**NOTICE OF DECISION TO CONSENT TO CHANGE TO PROPOSAL DURING
ASSESSMENT**

Northern Goldfields Interconnect Pipeline
Assessment No. 2284

STATEMENT OF REASONS

Proposal: Northern Goldfields Interconnect Pipeline

Figure 1: Northern Goldfields Interconnect Pipeline

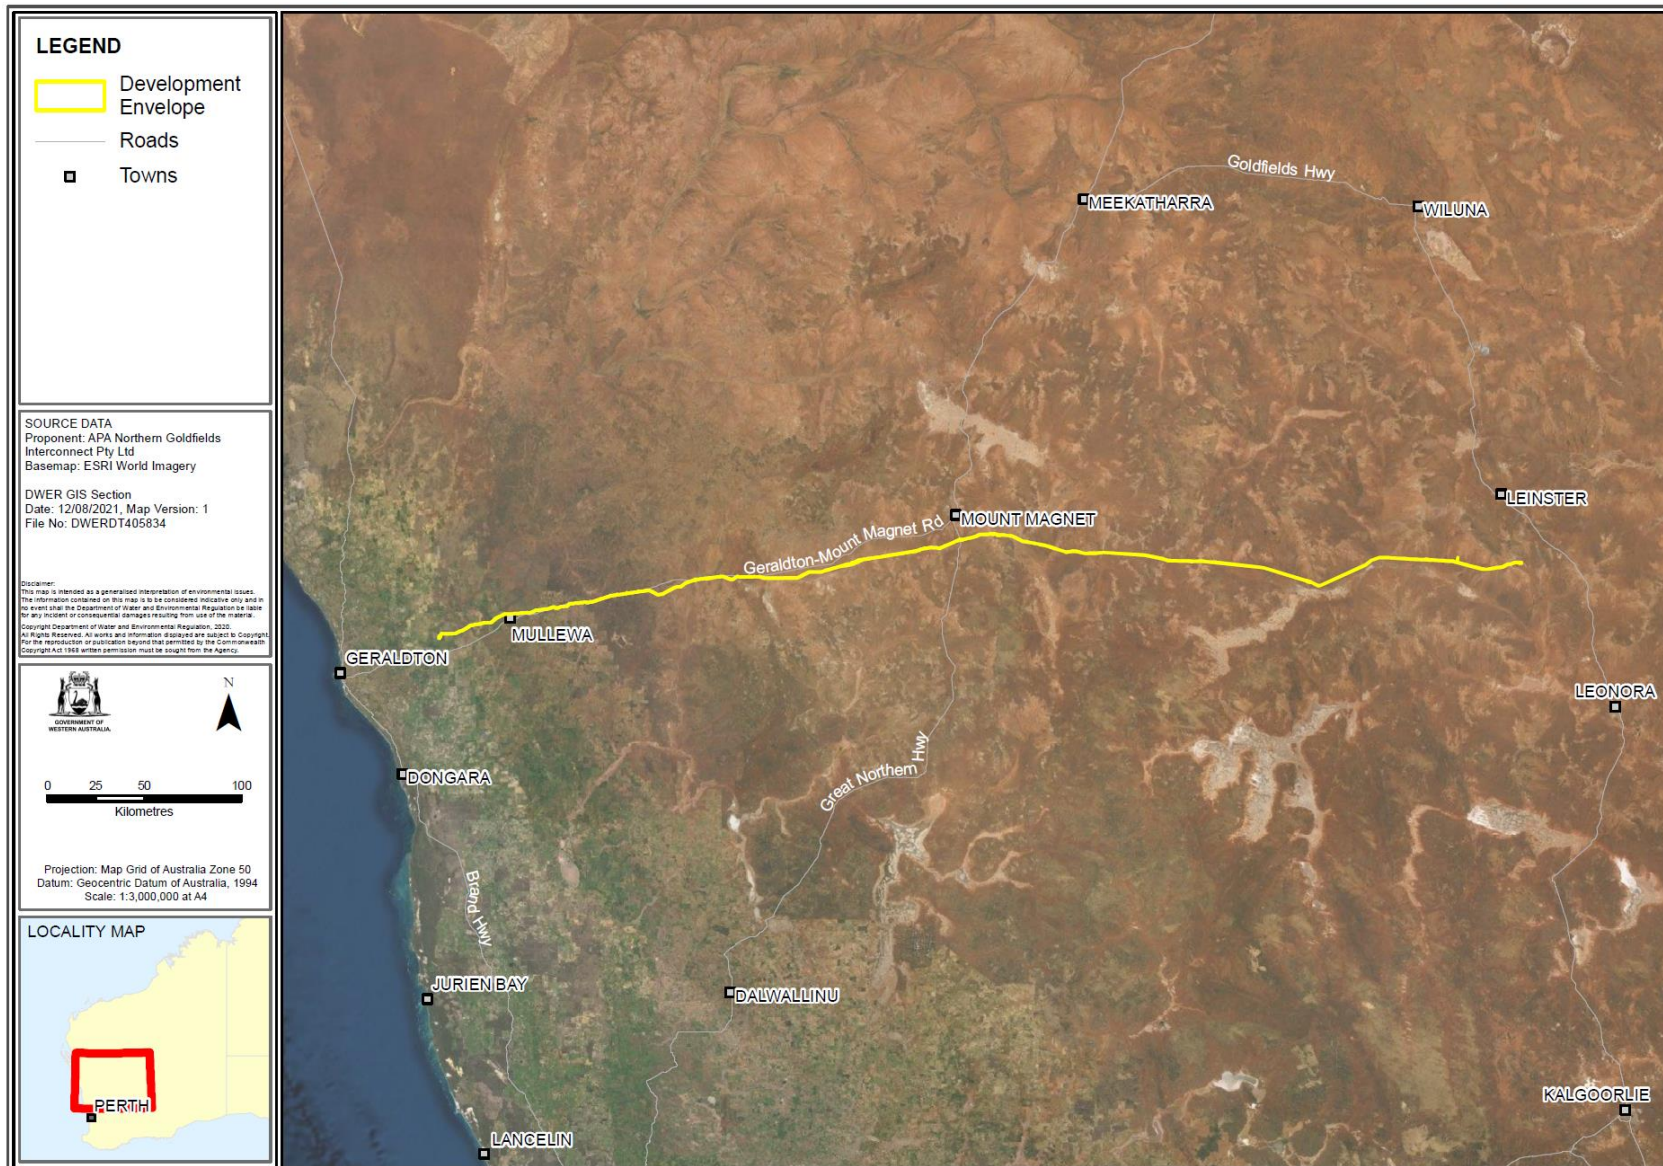
- 1) Buried NGI Pipeline disturbance footprint - A reduction of the disturbance footprint from 2,287 ha to 2,261.5 ha within a development envelope of 12,404 ha. Following a review of the construction methodology and consideration of sensitive areas, the pipeline alignment has been further refined resulting in a reduction in the clearing of native vegetation from 1,934 ha to 1,930 ha.
- 2) Construction right of way – The disturbance footprint has been reduced to 1,840.5 ha from 1,850 ha. Of this, 1,519.5 ha is native vegetation.
- 3) Pipeline laydown area and construction facilities – The disturbance footprint has been reduced from 395 ha to 377 ha. Of this, 369.5 ha is native vegetation.
- 4) Construction access points – The disturbance footprint has increased from 42 ha to 44 ha. Of this, 41 ha is native vegetation.

Element	Location	Proposed Extent
Physical elements		
Buried gas pipeline	Linear infrastructure extending the length of the development envelope. Figure 1	Clearing or disturbance within the development envelope of up to approximately 2,261.5 ha , comprised of approximately: <ul style="list-style-type: none"> • 1,930 ha of native vegetation; and • 331.5 ha of cleared land/pasture. <p>Within this, the aboveground facilities will require the following:</p> <ul style="list-style-type: none"> • Rosewick offtake – disturbance of up to 0.1 ha; • Ambania compressor station – disturbance of up to 4.1 ha; • Yoweragabbie scraper station – disturbance of up to 1.1 ha (inclusive of allowance for a future compressor); • Mainline valve stations – total disturbance of up to 0.6 ha; • Wildara delivery station – disturbance of up to 0.5 ha; and • Weebo inlet station– disturbance of up to 0.1 ha.
Aboveground facilities, including: <ul style="list-style-type: none"> • Rosewick offtake; Ambania compressor station; • Yoweragabbie scraper station; • Mainline valve stations; • Wildara delivery station; and • Weebo Inlet Station 	Located at various locations along the pipeline. The location of the Yoweragabbie Scraper Station will have suitable land available for the future option of the installation of an adjoining compressor station.

Construction elements		
Construction right of way (CROW), construction turnaround and passing bays and work areas, e.g. for underboring (i.e. horizontal directional drilling)	Located adjacent to the pipeline during construction.	Clearing or disturbance within the development envelope of up to approximately 1,840.5 ha . The clearing or disturbance will be located within native vegetation (approximately 1,519.5 ha) and cleared land/pasture (approximately 321 ha) Generally a 30 m wide corridor with extra areas for turnarounds and work areas
Pipeline laydown areas and construction facilities, including construction camps with mobile offices and ablutions, and equipment laydown areas	Where practicable, the pipeline laydown areas and temporary construction areas will be located in areas of existing disturbance. Up to six construction camps are proposed to support the Proposal. The construction camps will be	Clearing or disturbance within the development envelope of up to 377 ha . The clearing or disturbance will be located within native vegetation (approximately 369.5 ha) and cleared land/pasture (approximately 7.5 ha). Up to six construction camps may be required, each with associated offices, ablutions and laydown areas.

located within the development envelope or broader surrounds. In those circumstances where the camps are located external to the development envelope, they will be in existing cleared areas. The mobile offices and equipment laydown areas will be situated within the construction camps.	
Turkey nests	Located adjacent to the pipeline during construction.	Up to approximately eight turkey nests may be required for the Proposal. Each turkey nest is anticipated to be approximately 110 m x 90 m.
Construction access points/tracks	The access points/tracks will provide access to the CROW. Construction access will preferentially use existing tracks, where possible. Existing tracks may require improvement works, including widening, to facilitate access of larger vehicles (trucks) and machinery/equipment.	Clearing or disturbance of up to 44 ha may be cleared for construction access. The clearing or disturbance will be located within native vegetation (approximately 41 ha) and cleared land/pasture (approximately 3 ha)

Operational elements		
Operation of the constructed NGI pipeline and associated above ground facilities		APA will operate the pipeline system in accordance with regulatory and APA standards, and standard management and maintenance practices.
Operations right of way (ROW)	Located adjacent to the asbuilt NGI pipeline centreline	The operational area for the pipeline will generally require a 4 m wide access track located adjacent the pipeline warning markers and a mulched/cleared section over the buried pipeline. The access track will be maintained as a ROW along the NGI pipeline to provide access for operational site maintenance, including servicing, equipment and integrity checks and general site maintenance. The ROW will be located within the Pipeline Licence area. The establishment of the operational ROW will be limited in the western section of the pipeline (between approximately KP0 to KP80) to minimise the alignment's intersection with agricultural properties. It is anticipated that the operational ROW will have a disturbance area of approximately 200 ha.
